SUBJECT: TECHNICAL ASSISTANCE REQUEST REGARDING THE  
RADIOLOGICAL ASSESSMENT FOR THE CABOT - REVERE,  
PENNSYLVANIA SITE

# **Radiological Assessment for Cabot Corporation Revere, PA Site**

## **Technical Evaluation Report**

Figure 1. Generalized conceptual model used in the Cabot-Revere assessment.

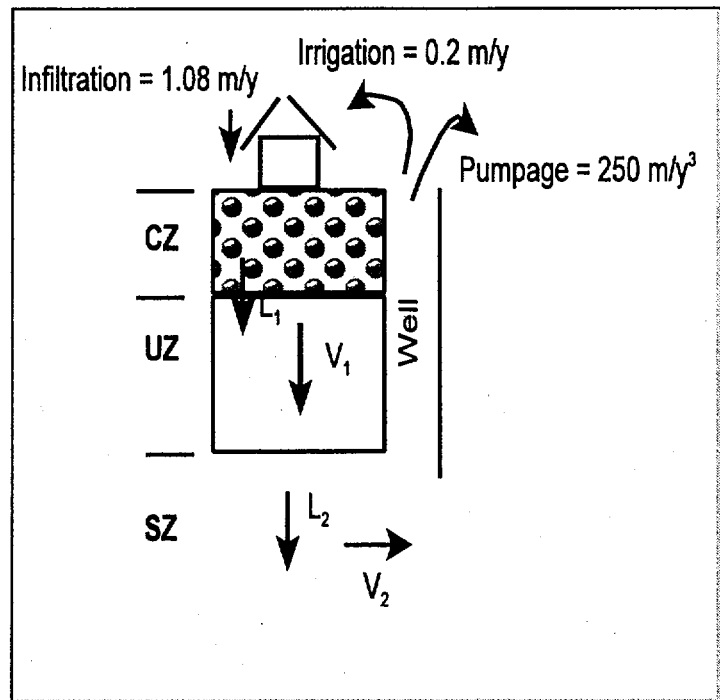
Figure 1 shows a schematic of the general conceptual model used in the Cabot-Revere radiological assessment, based upon staff's interpretation of the information presented in the report.

It should be noted that a default irrigation rate of 0.2 m/y was used in the analysis although the licensee only assumed irrigation as part of their residential gardener scenario.

Based on regional information, the unsaturated zone is believed to be roughly 20 meters thick; however, for the assessment nominal credit is taken for the possible hold-up of contaminants migrating through the unsaturated zone. This is reflected by the small unsaturated zone thickness (0.01 m) assumed for the analysis. Staff believes that this adds conservatism to the calculated doses for the water-dependent pathways.
